CHANGE PEDAL RETURN SPRING

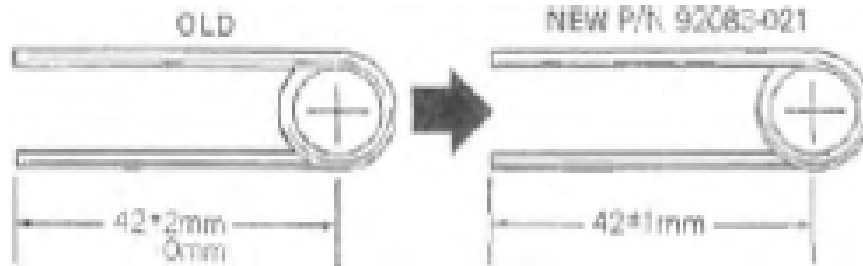
Description	OLD PART		NEW PART		INTER-CHANGEABILITY Old/New	Effective D.D.
	OLD P/N	REMARKS	NEW P/N	REMARKS		
Change pedal return spring	Not Available	42-44mm	92083-021	41-43mm		Engine No. Z1E-04921

If the change pedal return spring is the source of a shifting problem, replace or modify it using Job Code C045 (1.2 hrs.) ■
